Project: LODI UNIFIED SCHOOL DISTRICT
BEAR CREEK HIGH SCHOOL RESTROOMS MODERNIZATION

ADDENDUM 1

10/26/2023

A40.1

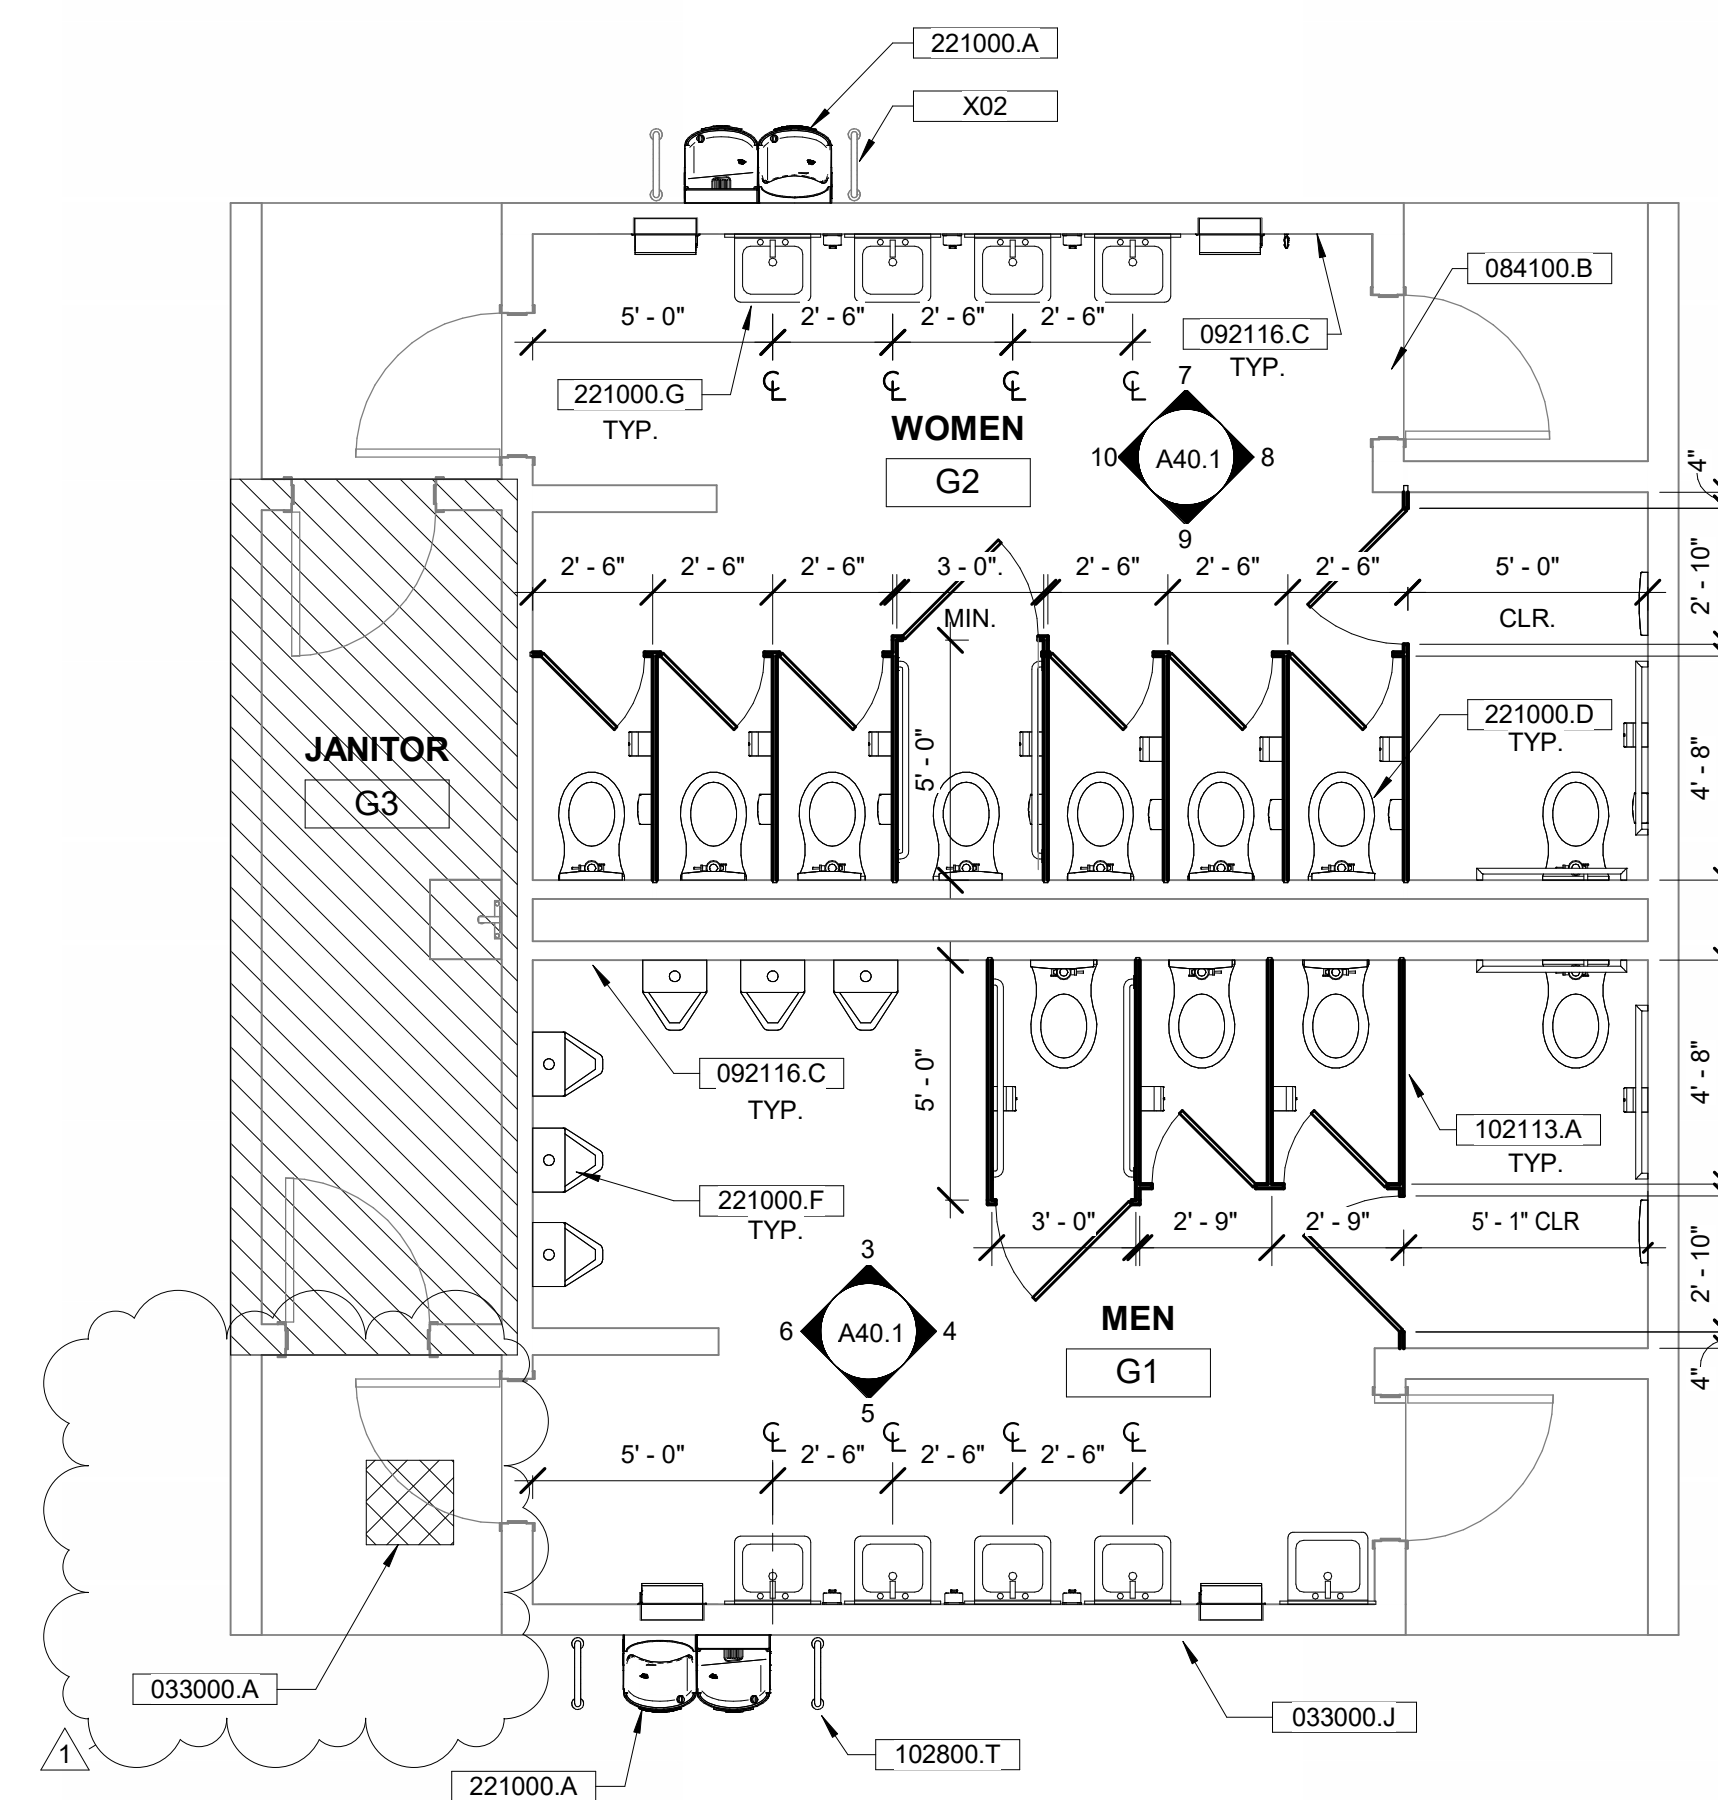
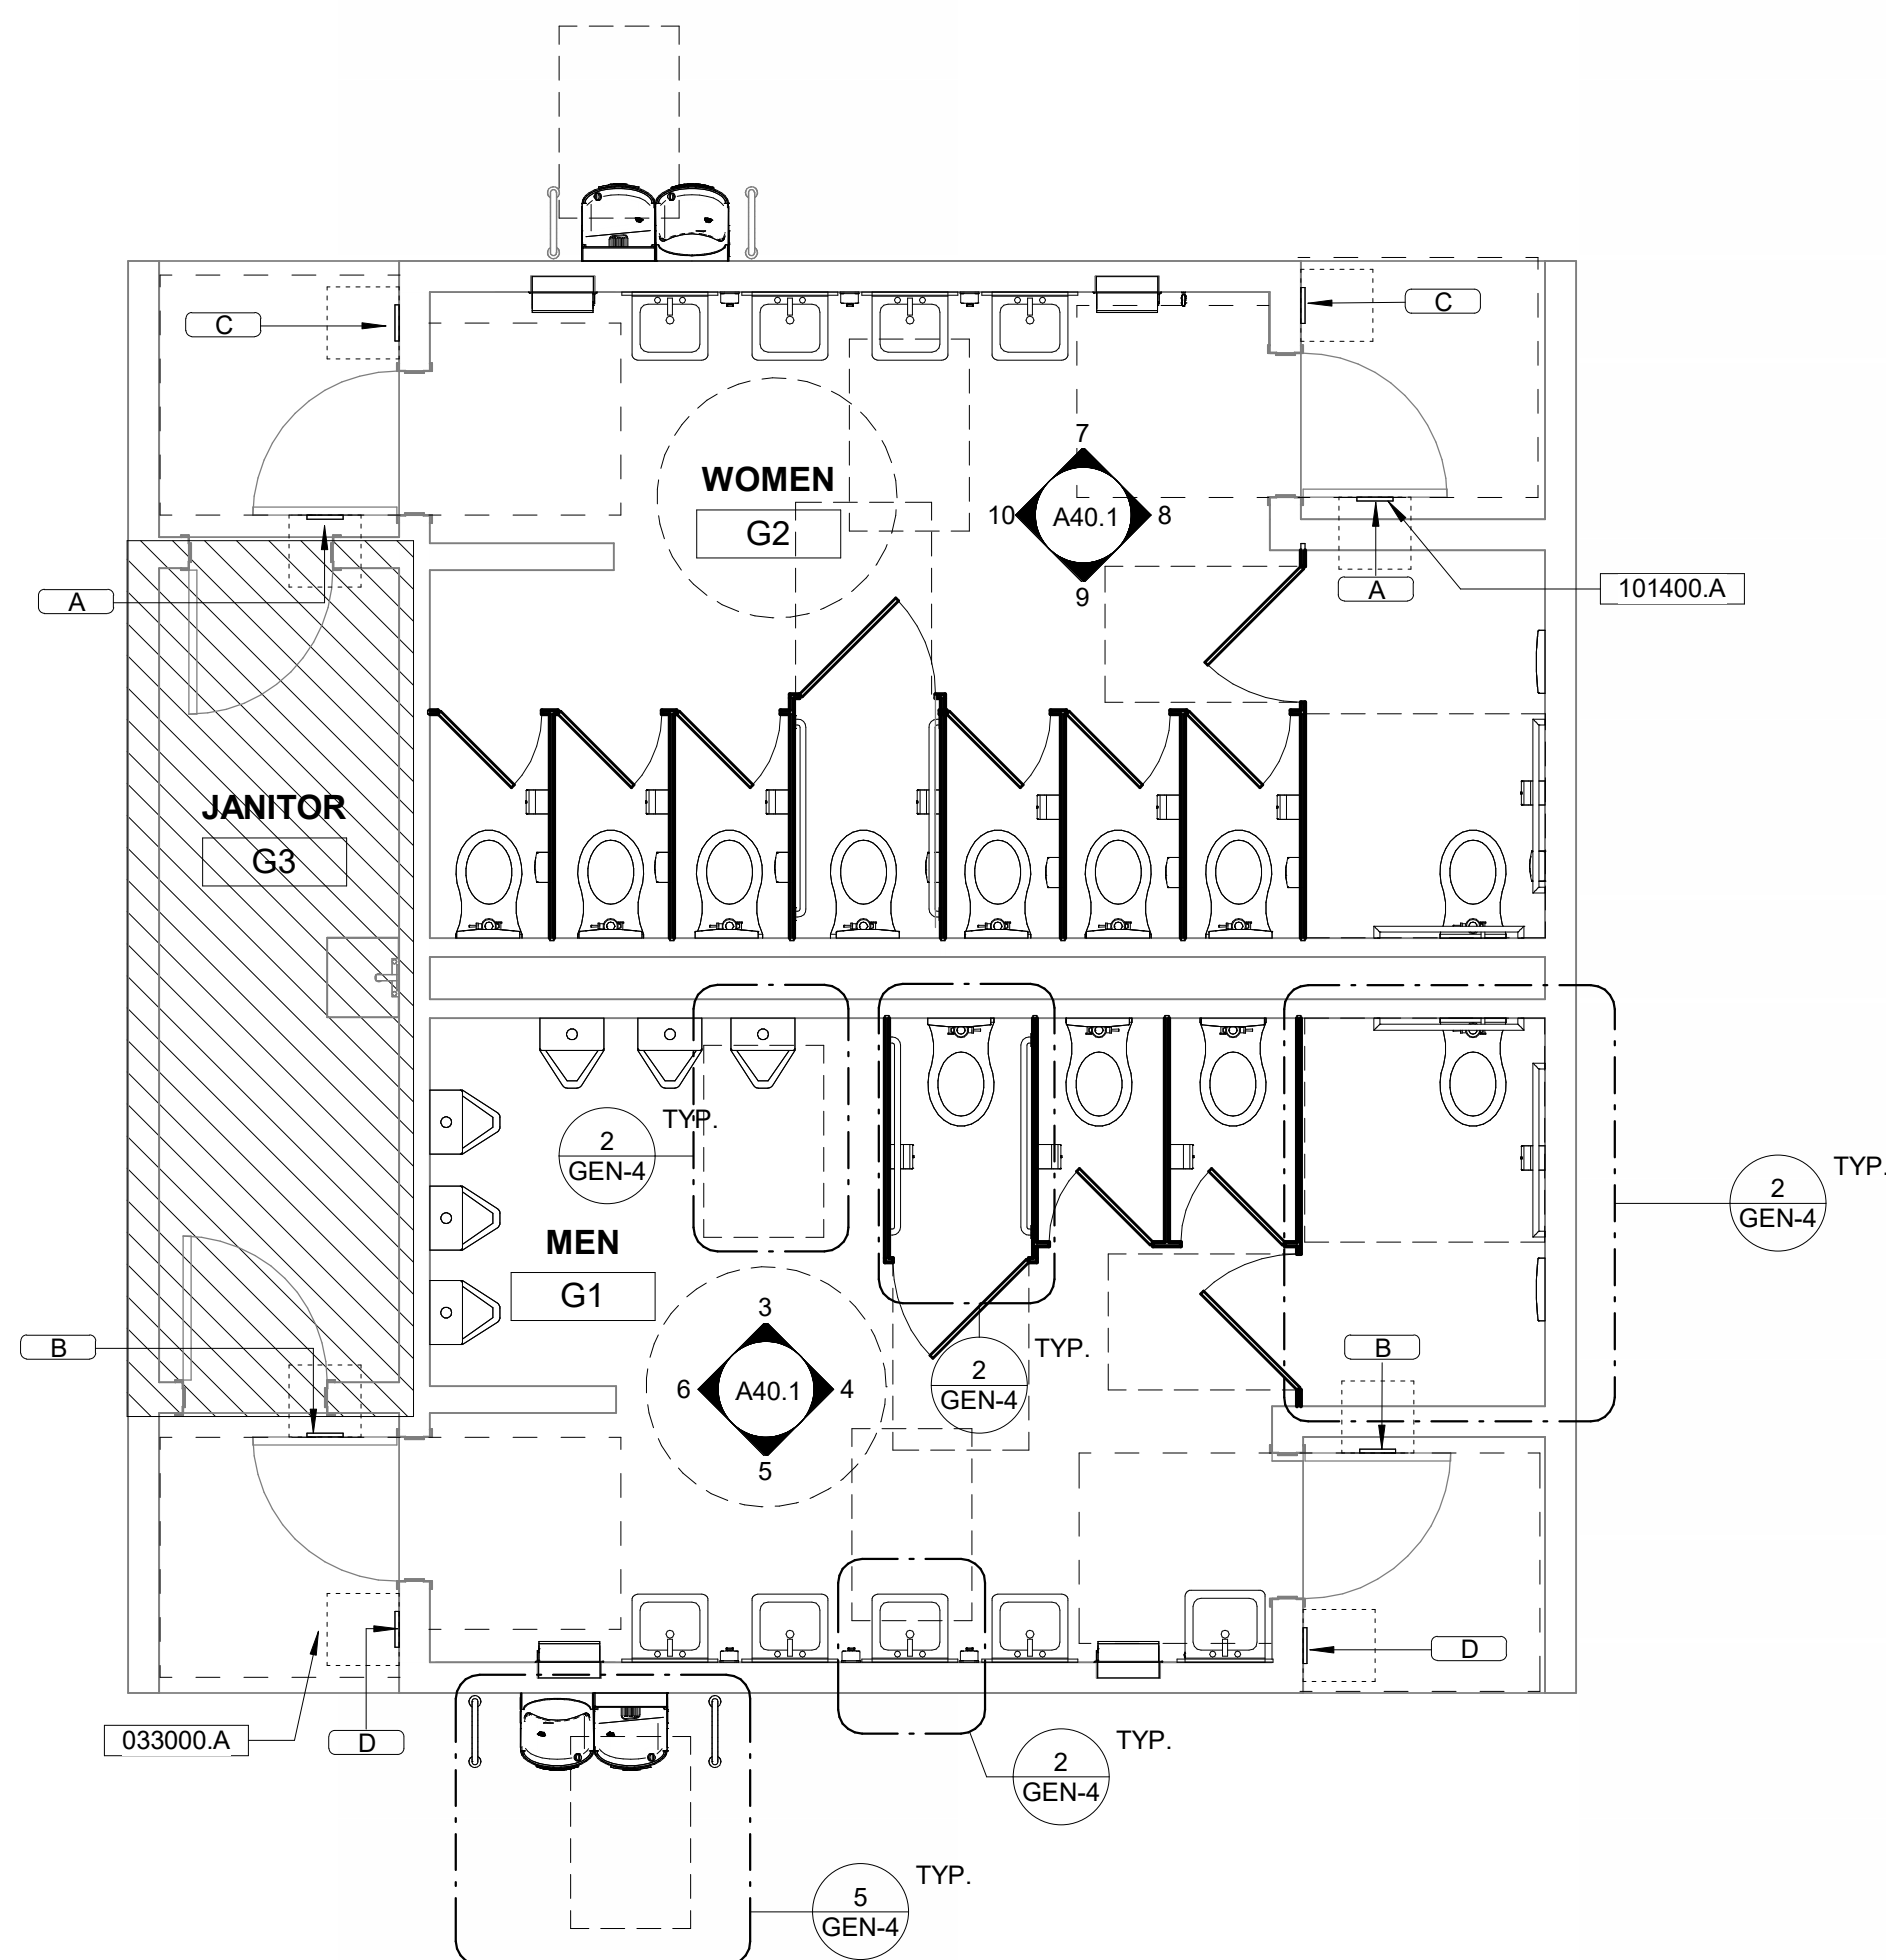
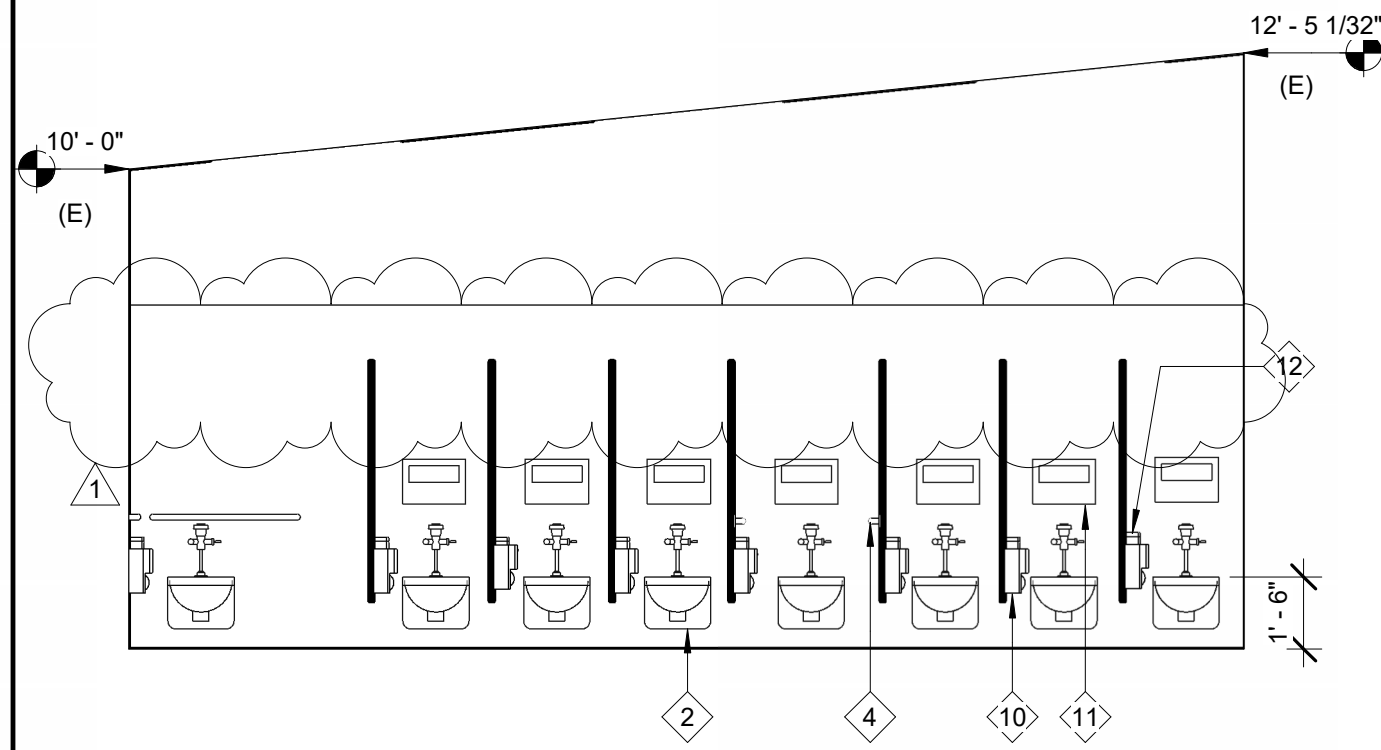
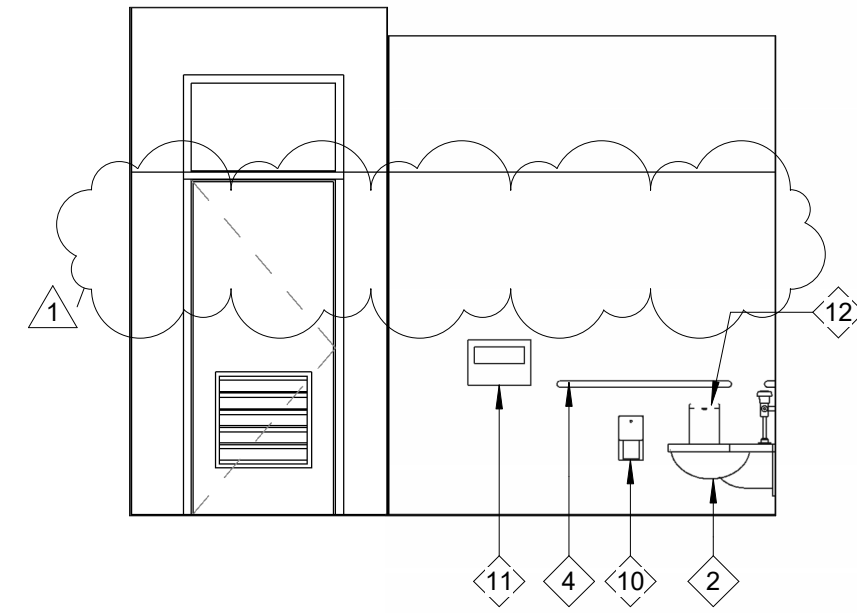
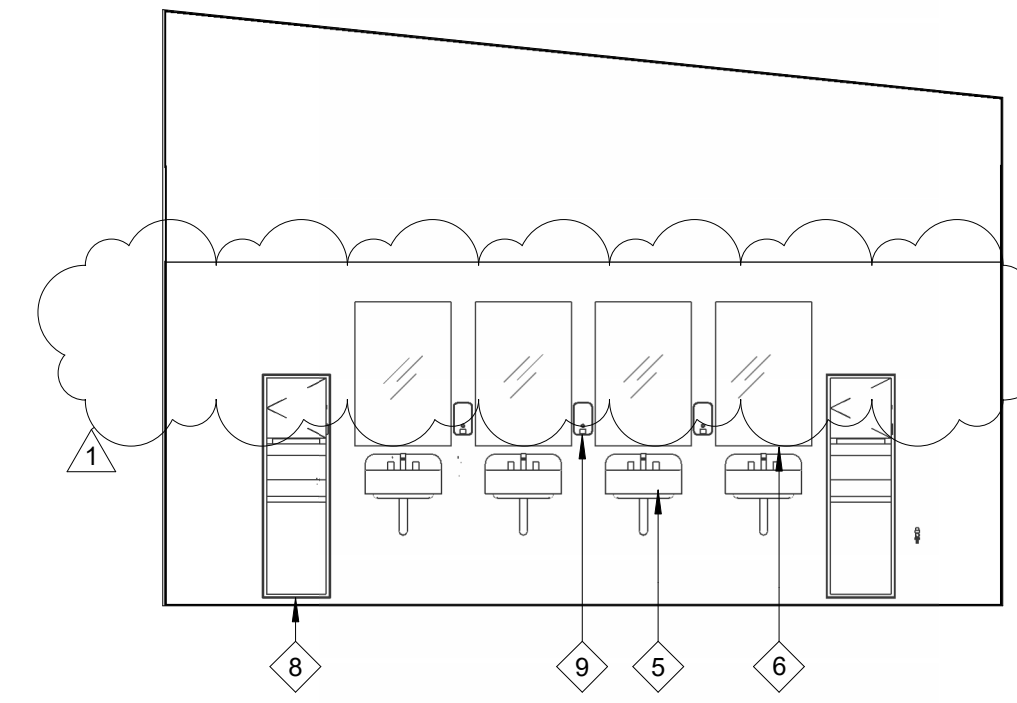
- a. Restroom Accessory Legend note 1 revised to call for solid plastic toilet compartment partitions
 - b. Remove keynote 096513.A
 - c. Show epoxy wainscot to +7'-2" with painted gypsum board above (no FRP)

- d. Revise keynote 033000.A to show patching concrete slab with cementitious repair compound
 - e. Revise floor plan to show concrete patch at damaged area

?	DESCRIPTION	A
033000.A	PATCH CONCRETE SLAB WITH CEMENTITIOUS REPAIR COMPOUND, PROVIDE LEVEL BROOM FINISH TO MATCH EXISTING.	
033000.J	PATCH WALL AT REMOVED DRINKING FOUNTAIN. FINISH TO MATCH EXISTING	
084100.A	PROVIDE (N) ACCESSIBLE ALUMINUM THRESHOLD, SEE SPECS.	
092116.A	GYPSUM BOARD WALL FINISH (PAINTED), SEE FINISH SCHEDULE	
092116.B	REPAINT (E) GYP CEILING. SEE FINISH SHCHEDULE	
092116.C	GYPSUM BOARD FINISH WITH WAINSCOT OVER (E) FRAMING, TYP. FOR ALL INTERIOR PARTITIONS WITHIN AREA OF WORK, SEE DETAIL 1/A50.1	
099000.D	EPOXY WAINSCOT WITH INTERAL BASE	A
101400.A	PROVIDE SIGN WHERE MISSING, SEE SHEET GEN-5 FOR INSTALLATION CRITERIA	
102113.A	TOILET COMPARTMENT, SEE SPECS. TYP.	
102800.T	(N) DRINKING FOUNTAIN GRAB BAR FOR, FOR DETAIL, SEE 3/GEN-4; FOR ACCESSIBILITY INFORMATION, SEE 5/GEN-4	
221000.A	(N) HI-LO ACCESSIBLE DRINKING FOUNTAIN WITH BOTTLE FILLER, SEE PLUMBING DRAWINGS, DETAIL 5/GEN-4 FOR ACCESSIBILITY INFORMATION, AND DETAIL 3/A50.1 FOR BACKING
